# Access Compliance Report

## Public Rights-of-Way

### (Curb Ramps)

Intersection ID: 48463	Main Street: PANGLEMONT_DR	Cross Street: CHANDLER_HAVEN_DR	Location:	N
ADA ID: A25E70AAFFCC2	Ramp Type: PerpDiag	Initial Pass/Fail: Fail	Overall Compliance: No	Severity Score: 8.75
Codes/Mitigation Info/Possible Solution		Field Measurements/Component Compliance

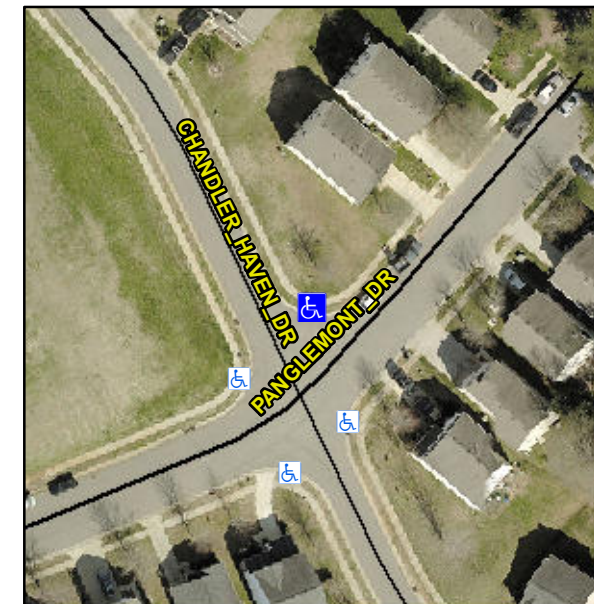
**Not Found, R304.5.1**

Compliance	Description	Data	Compliance	Description	Data
N/A	Ramp Length (in)	47.5	Yes	Ramp Slope (%)	7.2
No	Ramp Width (in)	46.5	Yes	Ramp XSlope (%)	2.0
N/A	Flare Type LT	N/A	N/A	Flare Type RT	N/A
N/A	Flare Slope LT (%)	N/A	N/A	Flare Slope RT (%)	N/A
N/A	Flare Traversable LT?	N/A	N/A	Flare Traversable RT?	N/A
N/A	Landing Length (in)	N/A	N/A	DWS Provided?	N/A
N/A	Landing Width (in)	N/A	N/A	DWS Contrast?	N/A
N/A	Landing Slope (%)	N/A	N/A	DWS Length (in)	N/A
N/A	Landing X Slope (%)	N/A	N/A	DWS Full Width?	N/A
N/A	Landing Curb? (Y/N)	N/A	N/A	DWS Offset (in)	N/A
N/A	Shared Landing?	N/A			
N/A	Gutter Ponding?	N/A	N/A	Gutter Slope (%)	N/A
N/A	Gutter Lip Ht (in)	N/A	N/A	Gutter X Slope (%)	N/A
N/A	Painted X Walk1?	No	N/A	Painted X Walk2?	No
	X Walk 1 Direction	To S		X Walk 2 Direction	To SW
N/A	X Walk 1 Width (in)	N/A	N/A	X Walk 2 Width (in)	N/A
	X Walk 1 Slope (%)	2.6		X Walk 2 Slope (%)	2.3
	X Walk 1 X Slope (%)	2.1		X Walk 2 X Slope (%)	1.0

**Remove & Replace Curb Ramp With Two New Directional Ramps or Equivalent.**
